Subject: Duke Energy Carolinas, LLC
William States Lee III Nuclear Station - Docket Nos. 52-018 and 52-019
AP1000 Combined License Application for the
William States Lee III Nuclear Station Units 1 and 2
Response to Request for Additional Information
Ltr# WLG2008.12-04

Lee Nuclear Station Response to Request for Additional Information (RAI)

Reference NRC RAI Numbers: ER RAIs 55 and 56

RIVER WATER INTAKE STRUCTURE LOCATION PLAN

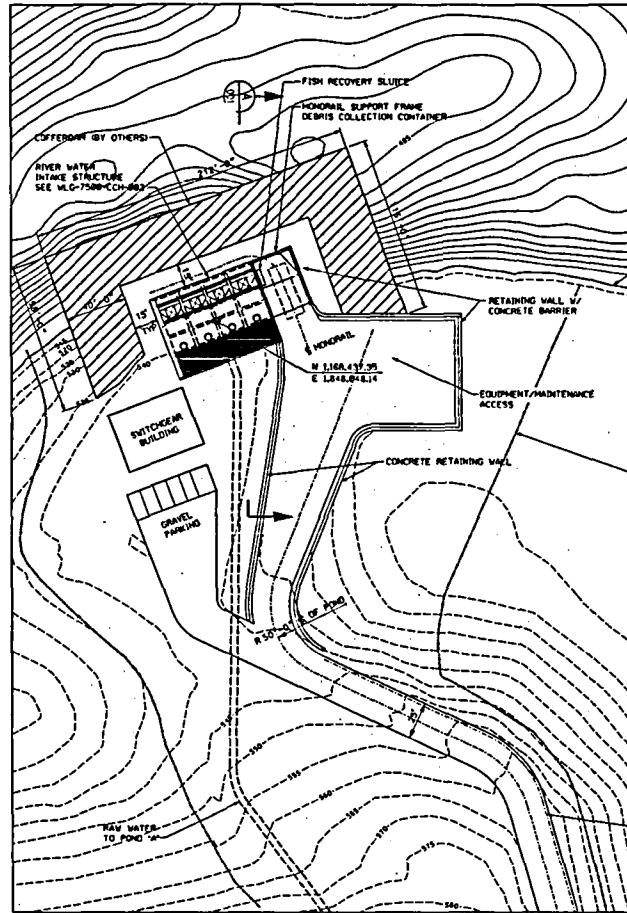
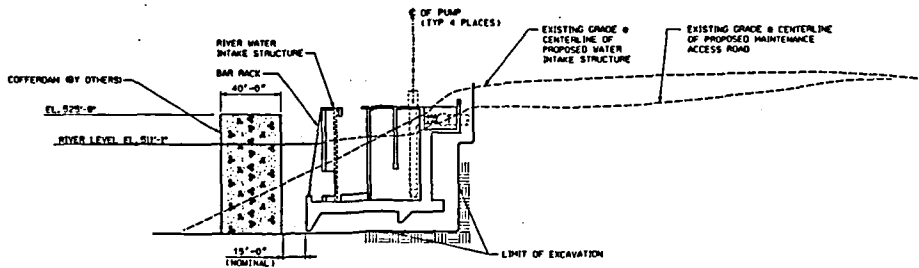
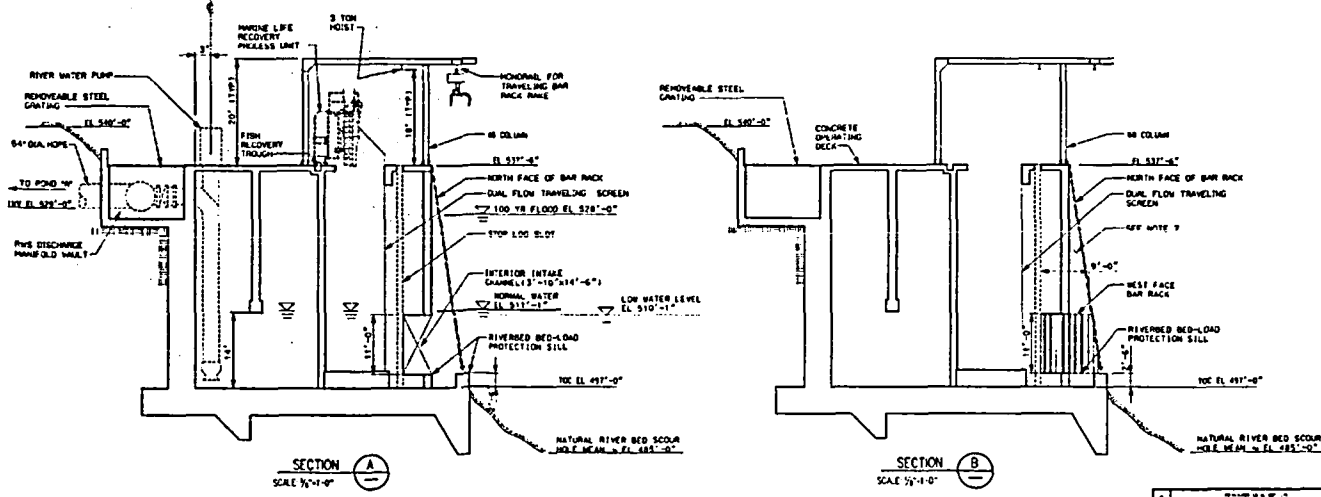
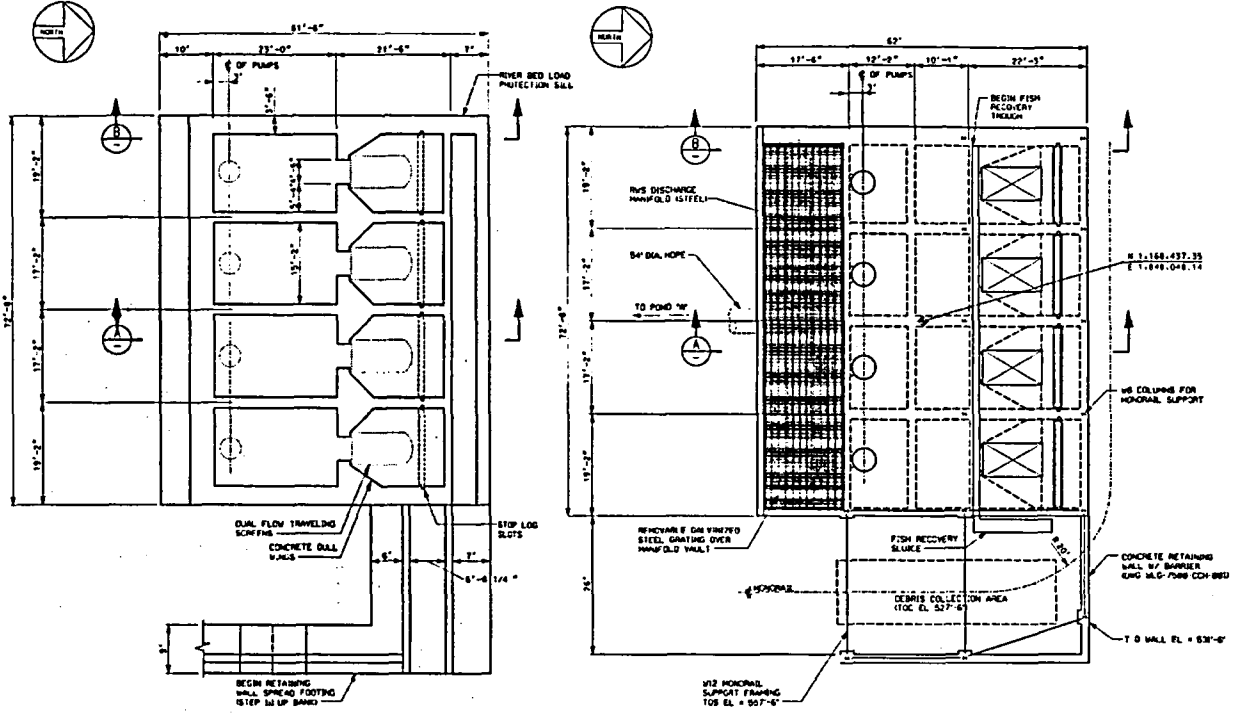
ER RAI 55: Provide the finalized Make - Up Ponds A and B intake structure designs and updated descriptions when they are available. Include information on any fish - friendly parts of the design, or indicate why they are not included in the final design.

ER RAI 56: Provide the finalized cooling water intake and discharge structure design and an updated description when it is available. Include information on traveling screens and parts of the design that make it "best available technology" for protecting aquatic organisms.

Preliminary drawings of the intakes and discharge structures are attached to this response. Drawings WLG-7500-CCH-001 and WLG-7500-CCH-002 provide existing conditions, plan arrangement, plan view, and sections for the river water intake. The intake will be equipped with traveling screens, with 3/8 inch or smaller mesh, installed in the vertical position and designed for continuous operation. The screens are of the modified "Ristroph" design with Fletcher type fish-friendly buckets on each screen basket. The screens have dual pressure spray header systems with separate fish and debris troughs. The troughs are supplied with supplemental flow sufficient to move the fish and debris through the separate return troughs. The fish return trough will exit the intake on the downriver side and return the fish to the section of the Broad River. The river water traveling screens are designed to provide a through velocity that is less than 0.5 foot per second. After passing through the intake the water is conveyed by a pipe to the northwest corner of Make-Up Pond A where it is discharged into Make-Up Pond A through a surface outfall.
